Docket Items # 10 & 11 BAR CASE # 2015-0039/0040

BAR Meeting March 18, 2015

**ISSUE:** Permit to Demolish (shed) and New Construction and Waiver of HVAC

**LOCATION:** 533 North Columbus Street

PROPOSED WEST ELEVATION

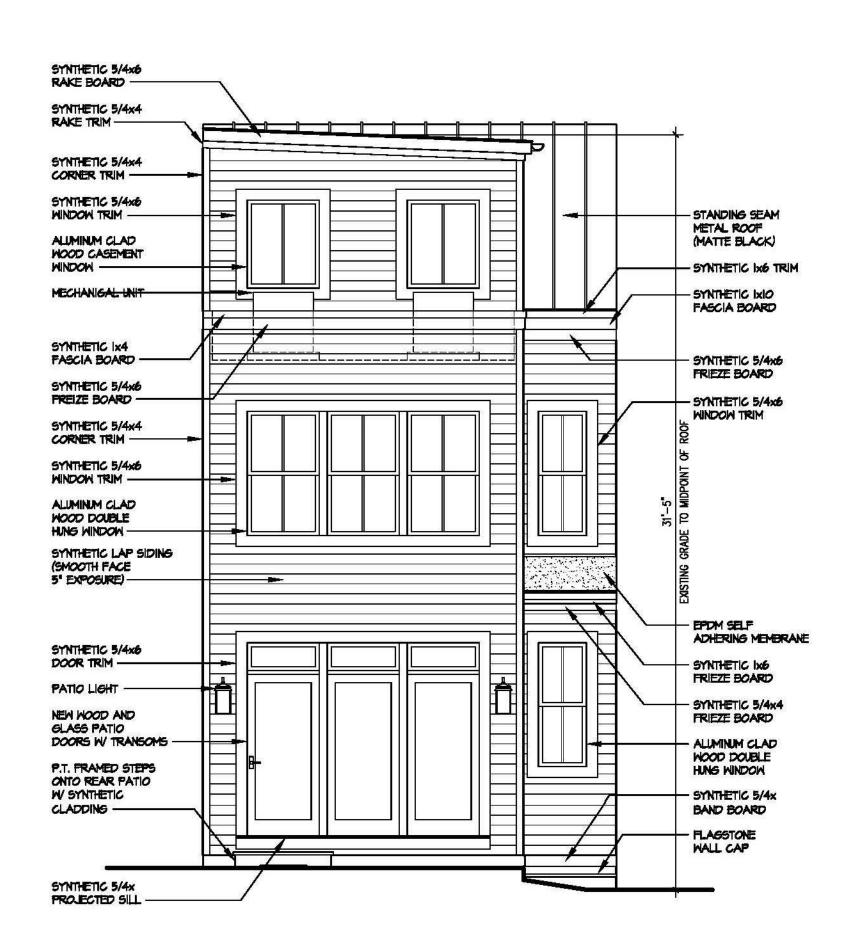
- 1. The new windows comply with the Board's Window Policy;
- 2. The window headers on the first floor be replaced with a smaller header to be approved by staff;

The front elevation of the house will have a first floor bay window with a pronounced cornice and decorative brackets. The four-panel wood door will also have a deep overhang with a glass transom and solid panel where the house numbers will be installed. The front stoop, stairs and railings will be constructed of wrought iron. On the second floor, there will be three, two-over-two double-hung windows. The cornice will have the same brackets that are on the bay window and door overhang.
